February 10, 2006  
NRC:06:007

**Response to a Request for Additional Information Regarding Evaluation of a Potential Safety Significant Issue Pursuant to 10CFR21(a)(2)**

### Request for Additional Information Regarding Evaluation of a Potential Safety Significant Issue Pursuant to 10CFR21(a)(2)

Figure 1. Locations of the CRDMs in B&W PWRs

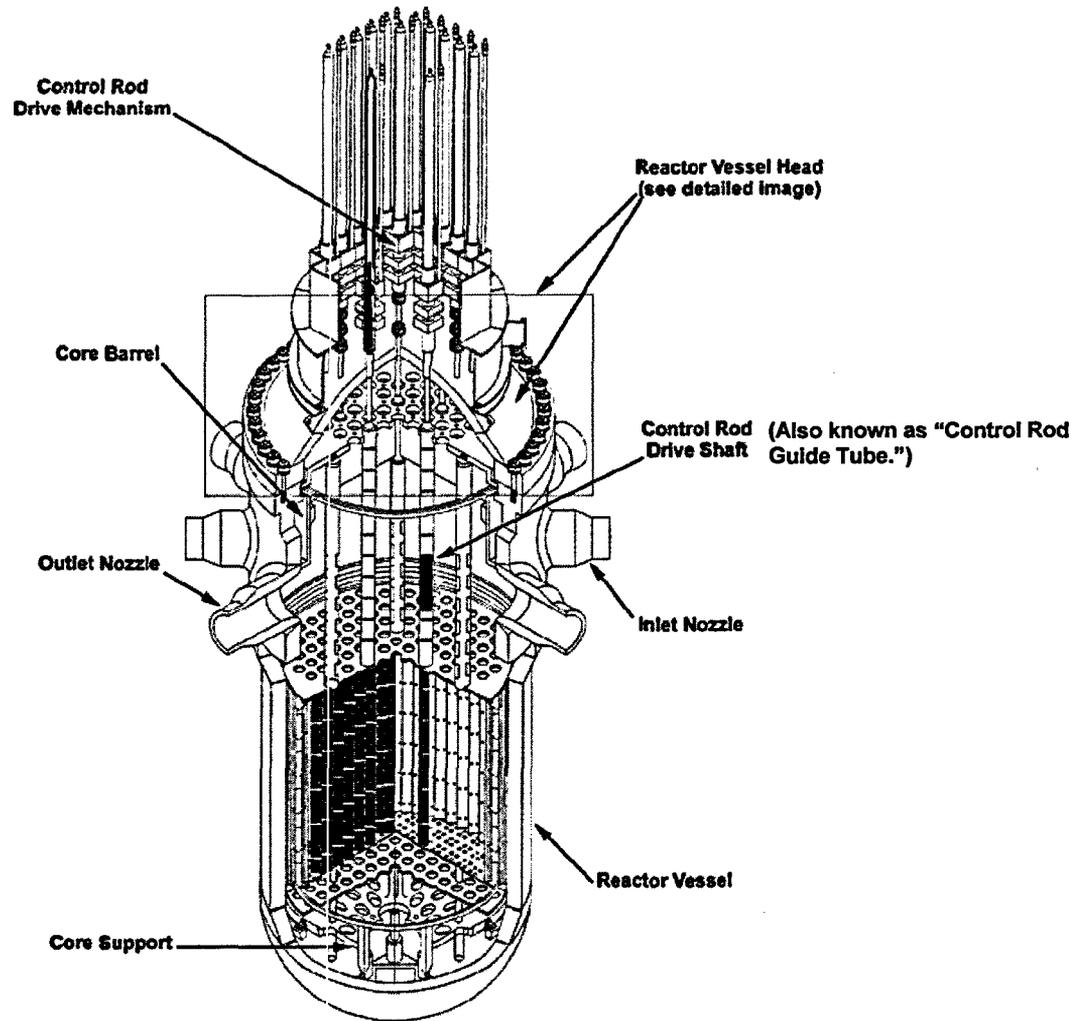
**Question 1E:** *Related drawing of the subject part.*

**Question 5:** *Provide a detailed drawing showing CRDM leadscrew male coupling (bayonet).*

See Figure 1 through Figure 6 below.

The CRDMs for the B&W designed 177-FA (fuel assembly) PWR is schematically shown in Figure 1 and the reactor vessel internals is shown in Figure 2. The CRDMs are mounted on the reactor vessel head and are used to raise, lower, or maintain control rod assembly (CRA) position within the reactor core. The CRDMs are electro-mechanical devices (see Figure 3), which convert the rotary motion imposed by a magnetic field into linear motion of the control rod by using the leadscrew and roller nuts. The leadscrew is connected to the CRA by inserting the male coupling at the end of the leadscrew into the female coupling on the top of the CRA (see Figure 4). Figure 5 shows an unused male coupling and a male coupling with a fractured tang removed from Oconee 3 in 2001. Figure 6 shows the detail of the fracture locations and fracture surfaces.
